Access Compliance Report

Public Rights-of-Way

Intersection ID: 31725	Main Street: MOSSYCUP_DR	Cross Street: GOLDENWILLOW_DR	Location: W
ADA ID: B8D79FD18E8A	Ramp Type: Perp	Initial Pass/Fail: Fail	Overall Compliance: No
Severity Score: 10			
Codes/Mitigation Info/Possible Solution		Field Measurements/Component Compliance

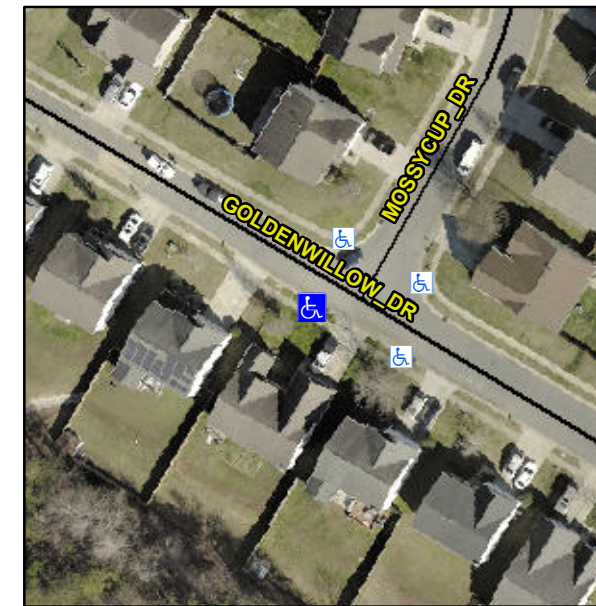
Not Found, R304.5.1

Compliance	Description	Data	Compliance	Description	Data
N/A	Ramp Length (in)	49.0	Yes	Ramp Slope (%)	5.9
No	Ramp Width (in)	47.0	Yes	Ramp XSlope (%)	2.3
N/A	Flare Type LT	N/A	N/A	Flare Type RT	N/A
N/A	Flare Slope LT (%)	N/A	N/A	Flare Slope RT (%)	N/A
N/A	Flare Traversable LT?	N/A	N/A	Flare Traversable RT?	N/A
N/A	Landing Length (in)	N/A	N/A	DWS Provided?	N/A
N/A	Landing Width (in)	N/A	N/A	DWS Contrast?	N/A
N/A	Landing Slope (%)	N/A	N/A	DWS Length (in)	N/A
N/A	Landing X Slope (%)	N/A	N/A	DWS Full Width?	N/A
N/A	Landing Curb? (Y/N)	N/A	N/A	DWS Offset (in)	N/A
N/A	Shared Landing?	N/A			
N/A	Gutter Ponding?	N/A	N/A	Gutter Slope (%)	N/A
N/A	Gutter Lip Ht (in)	N/A	N/A	Gutter X Slope (%)	N/A
N/A	Painted X Walk1?	No	N/A	Painted X Walk2?	N/A
	X Walk 1 Direction	To NE		X Walk 2 Direction	N/A
N/A	X Walk 1 Width (in)	N/A	N/A	X Walk 2 Width (in)	N/A
	X Walk 1 Slope (%)	1.3		X Walk 2 Slope (%)	N/A
	X Walk 1 X Slope (%)	3.1		X Walk 2 X Slope (%)	N/A

Remove & Replace Entire Ramp.
